NORTH VALLEY WATER DISTRICT

October 3, 2007

RE: Information requested from North Valley Water District
regarding public hearing on Enbridge Petroleum- Case No. PU-07-75
and PU-07-108

4 ENBRIDGE GAS PIPELINE CROSSING DETAIL
5 SCALE: NONE

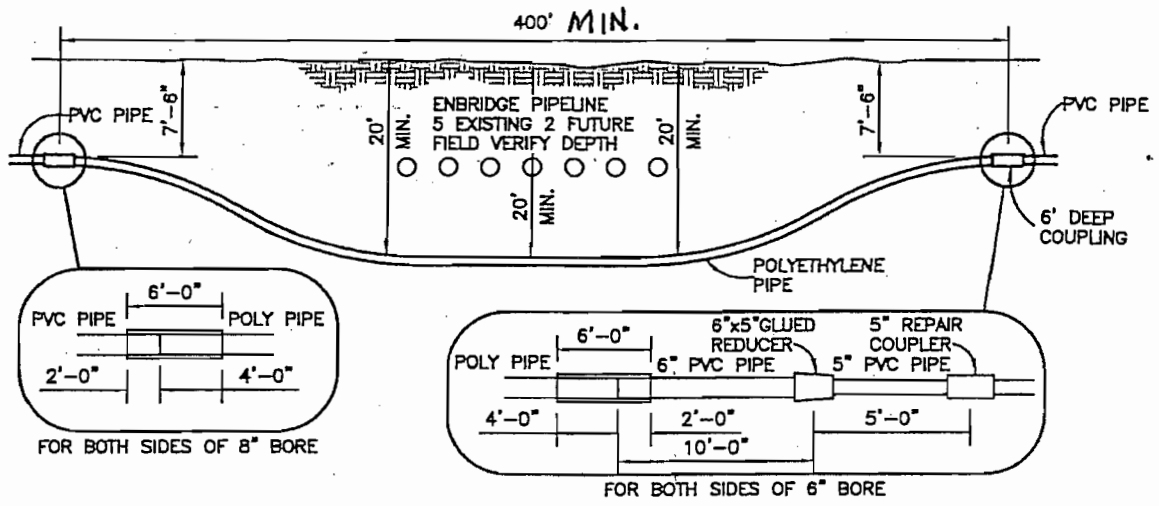
I am enclosing a detail drawing for one of the locations where NVWD has planned some pipeline work with two pipelines in parallel that would be bored under Enbridge's pipeline corridor.

This would be a typical profile of the type of installation that I suggested in my testimony. This detail is my submittal for the information you requested.

To minimize any disruption to water service or any exposure to public health risks from contamination, I suggest that Enbridge be responsible for the cost of directional boring and installation of heat-fused polyethylene pipe under Enbridge's pipeline corridor at a minimum of 20-foot depth below natural ground, or a 10-foot minimum separation under Enbridge's deepest pipeline.

At the hearing, I suggested a horizontal distance of 500 feet to allow for any future Enbridge pipelines.
